PUBLIC SERVICE COMPANY

Subj: Special Nuclear Material License
Response to NRC Questions for
Palo Verde Nuclear Generating Station
Docket No. 70-2949 (SNM-1887)

Attachment
NOS 82-144
Page 1
February 16, 1982

Figure
4.3-2

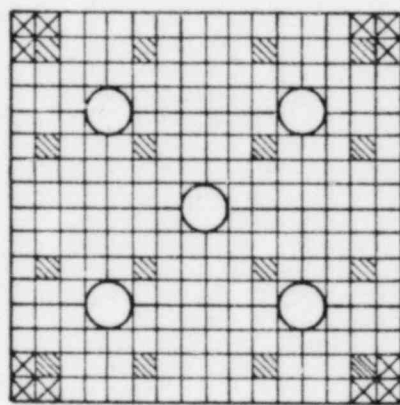
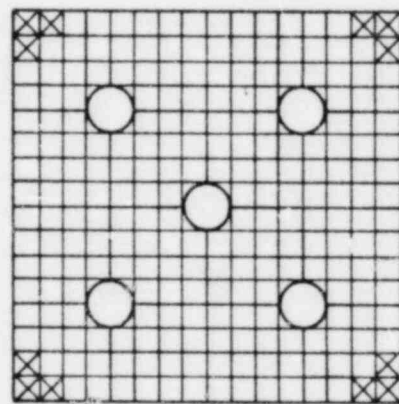
Describe the fuel assemblies in sufficient detail so that a nuclear criticality safety evaluation of the fuel handling and storage may be made (e.g., number and location of fuel rods and number of void positions/fuel assembly).

The PVNGS FSAR Section 4.2 refers to CESSAR Section 4.2 for a description of the fuel assemblies. Please find attached amended CESSAR Section 4.2.2.1 which provides a description of the fuel assemblies, including associated figures and including amended Table 4.2-1 showing the mechanical design parameters. These amended CESSAR Sections were forwarded to the NRC on CE Docket STN-50-470F in response to NRC Request for Additional Information, letter dated October 8, 1981. (LD81-069) Also attached is Figure 4.3-2 which provides the first cycle assembly fuel loadings and indicates the water hole and shim placement. (Reference Attachment 1) These changes will be included in a future CESSAR amendment.
